**TOWN OF TIMNATH, COLORADO  
ORDINANCE NO. 23, SERIES 2025**

**AN ORDINANCE AMENDING CHAPTER 18, ARTICLE 6,  
OF THE TOWN MUNICIPAL CODE  
TO ADOPT CERTAIN AMENDMENTS TO THE INTERNATIONAL FIRE CODE,  
PROMULGATED BY THE INTERNATIONAL CODE COUNCIL, 2024 EDITION,  
ADOPTED BY REFERENCE BY THE TOWN**

### Additional 2024 International Fire Code Amendments

**FIGURE D103.1 - DEAD END FIRE APPARATUS ACCESS ROAD TURNAROUND**

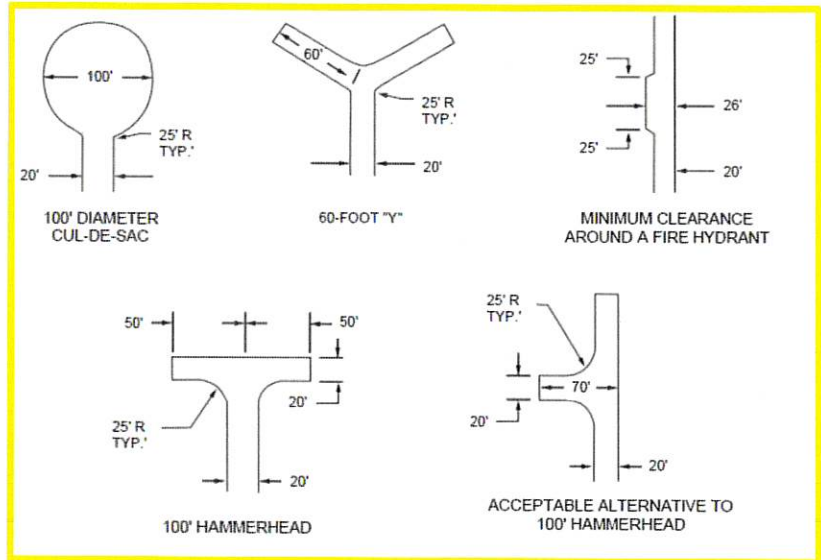
86. **APPENDIX D FIRE APPARATUS ACCESS ROADS**, which was deleted in its entirety and replaced is hereby amended as follows:

**D103.6 Dead Ends.** Dead-end *fire apparatus access roads* in excess of 150 feet (46 m) shall be provided with width and turnaround provisions in accordance with Table D103.6 (see Figure D103.6).
